Access Compliance Report

Public Rights-of-Way

(Curb Ramps)

Intersection ID: 12299	Main Street: W_MOREHEAD_ST	Cross Street: S_CHASE_ST	Location:	N
ADA ID: 33ACFAA82F98	Ramp Type: PerpDiag	Initial Pass/Fail: Fail	Overall Compliance: No	Severity Score: 25
Codes/Mitigation Info/Possible Solution		Field Measurements/Component Compliance

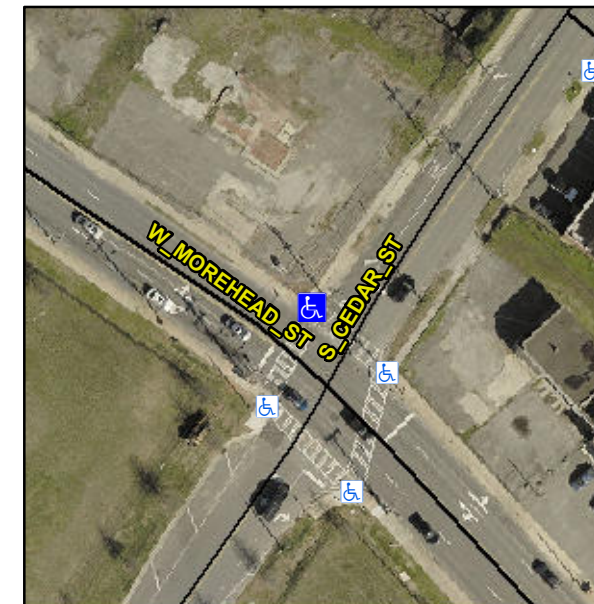
Not Found, R304.5.3

Compliance	Description	Data	Compliance	Description	Data
N/A	Ramp Length (in)	43.0	Yes	Ramp Slope (%)	7.7
Yes	Ramp Width (in)	48.0	No	Ramp XSlope (%)	7.6
N/A	Flare Type LT	N/A	N/A	Flare Type RT	N/A
N/A	Flare Slope LT (%)	N/A	N/A	Flare Slope RT (%)	N/A
N/A	Flare Traversable LT?	N/A	N/A	Flare Traversable RT?	N/A
N/A	Landing Length (in)	N/A	N/A	DWS Provided?	N/A
N/A	Landing Width (in)	N/A	N/A	DWS Contrast?	N/A
N/A	Landing Slope (%)	N/A	N/A	DWS Length (in)	N/A
N/A	Landing X Slope (%)	N/A	N/A	DWS Full Width?	N/A
N/A	Landing Curb? (Y/N)	N/A	N/A	DWS Offset (in)	N/A
N/A	Shared Landing?	N/A			
N/A	Gutter Ponding?	N/A	N/A	Gutter Slope (%)	N/A
N/A	Gutter Lip Ht (in)	N/A	N/A	Gutter X Slope (%)	N/A
N/A	Painted X Walk1?	Yes	N/A	Painted X Walk2?	Yes
	X Walk 1 Direction	To SW		X Walk 2 Direction	To SE
N/A	X Walk 1 Width (in)	105.0	N/A	X Walk 2 Width (in)	115.0
	X Walk 1 Slope (%)	6.4		X Walk 2 Slope (%)	5.0
	X Walk 1 X Slope (%)	4.9		X Walk 2 X Slope (%)	5.2

N/A	Ramp inside XWalk1?	Yes	N/A	Ramp inside XWalk2?	Yes
	Road Slope (%)	0.2	N/A	Clear Space?	N/A
	Road X Slope (%)	10.7	N/A	Clear Space to XWalk (in)	N/A
N/A	Any Obstructions?	N/A	N/A	Storm Grate/Utility Hazard?	N/A
	Obstruction Type			Storm Grate/Utility Type	
		N/A			N/A
			Yes	Surface Condition? (G/P)	Good

Remove & Replace Curb Ramp With Two New Directional Ramps or Equivalent.
